**CERTIFICATE OF APPROPRIATENESS**

**Property:** 642 Heights Boulevard, Lot 23, Block 277, Houston Heights Subdivision. The property includes a historic 1,235 square foot one-story brick veneered residence situated on a 7,500 square foot (50' x 150') interior lot.

**Proposal:** Alteration – Resubmittal – Construct a 2,281 square foot, two-story rear addition clad in cedar bevel siding to a contributing 1,310 square foot one-story brick residence. The addition will have a ridge height of 28' and an eave height of 21'.

**Recommendation:** Approval

WEST ELEVATION – FRONT FACING HEIGHTS BOULEVARD

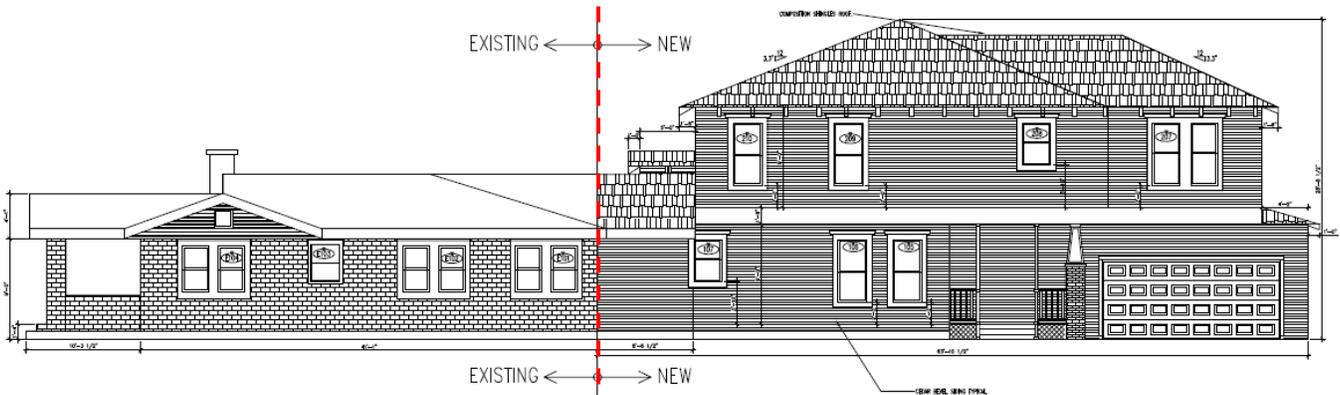
AGENDA ITEM #B24 – 642 Heights Blvd. – NO OBJECTION

There is a clear visual definition of the proposed addition (exterior materials) being different from the existing structure. The frontal plane area of the addition is not greater than the frontal plane area of the existing structure from the street.
